SUBJECT: NuScale Power, LLC Submittal of the Approved Version of NuScale Topical Report "Accident Source Term Methodology," TR-0915-17565, Revision 3

NuScale Topical Report, TR-0915-17565-NP-A, "Accident Source Term Methodology," Revision 4, nonproprietary version

Section A

Figure 5-13. Baseline case aerosol concentration and removal

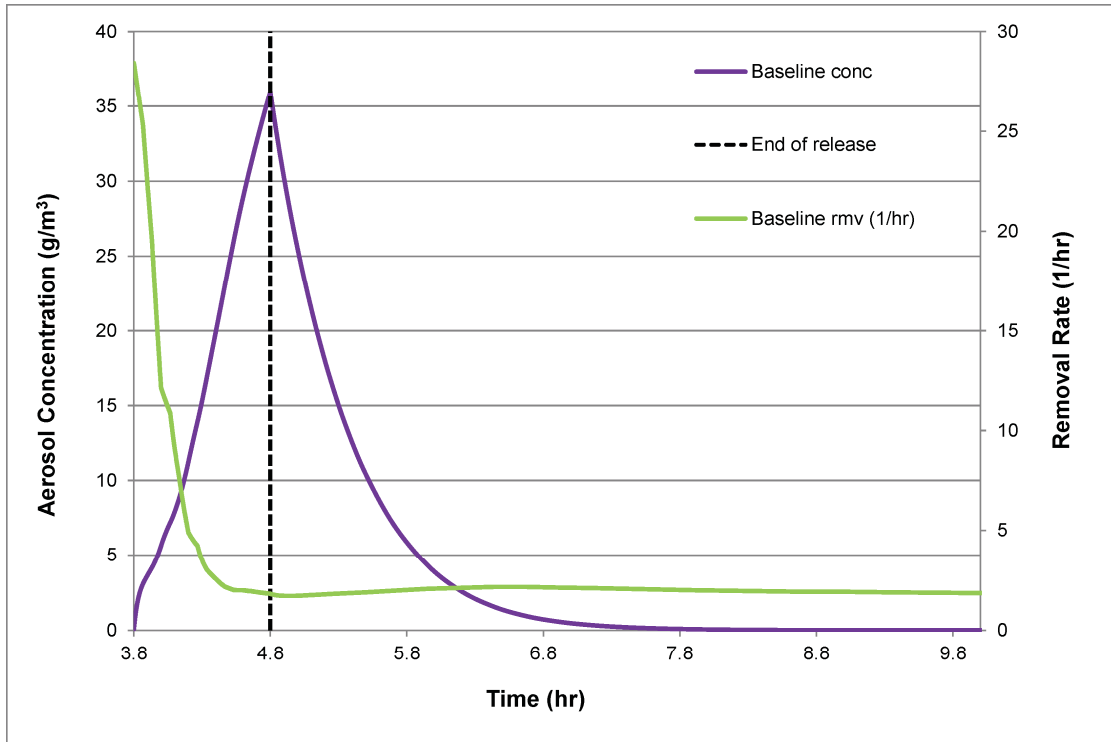
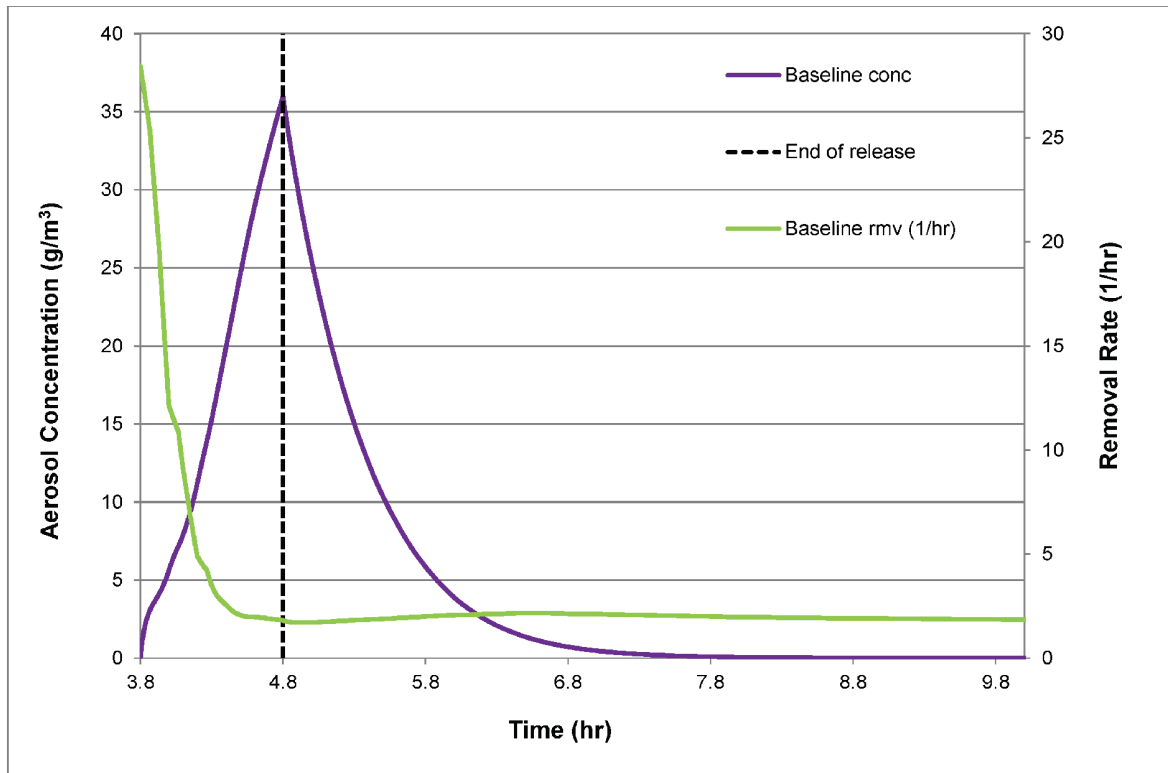
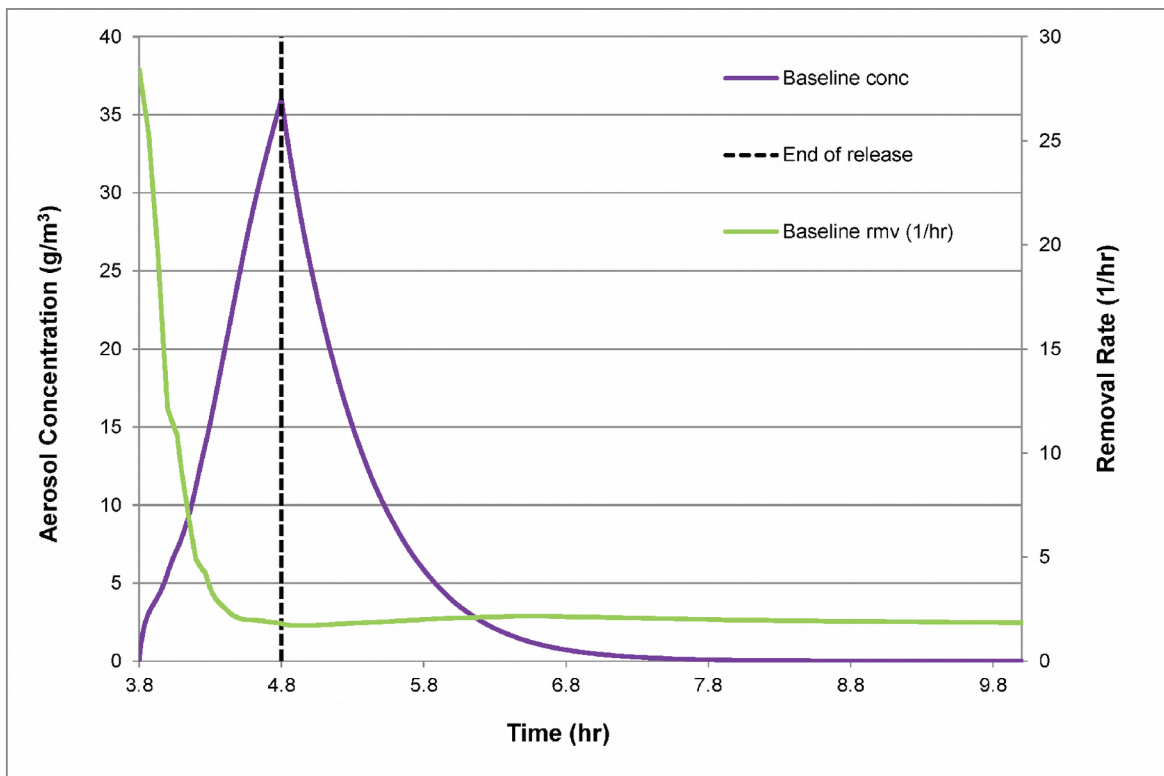
4. With respect to the example implementation of the methodology on aerosol removal, the two curves (aerosol concentration and aerosol removal rate constant) in Figure 5-13 of the TR appear to be inconsistent with each other. For the period beginning at the end of the release, the decrease in the aerosol concentration has a lower removal rate than shown in the removal rate constant curve. Please clarify this apparent inconsistency and how the curves were calculated.

4. With respect to the example implementation of the methodology on aerosol removal, the two curves (aerosol concentration and aerosol removal rate constant) in Figure 5-13 of the TR appear to be inconsistent with each other. For the period beginning at the end of the release, the decrease in the aerosol concentration has a lower removal rate than shown in the removal rate constant curve. Please clarify this apparent inconsistency and how the curves were calculated.

4. Figure 5-13 of TR-0915-17565-P, Rev. 2 was in error because of an internal post-processing error in the STARNAUA software. The vendor has been notified and the error has been addressed. NuScale will update Figure 5-13 and other associated STARNAUA example results in TR-0915-17565-P, Rev. 3. Figure 2 of this RAI response shows Figure 5-13's replacement that will be incorporated into TR-0915-17565-P, Rev. 3.

4. Figure 5-13 of TR-0915-17565-P, Rev. 2 was in error because of an internal post-processing error in the STARNAUA software. The vendor has been notified and the error has been addressed. NuScale has updated Figure 5-13 and other associated STARNAUA example results in TR-0915-17565-P, Rev. 3. Figure 2 of this RAI response shows Figure 5-13's replacement that has been incorporated into TR-0915-17565-P, Rev. 3 as Figure 5-13.
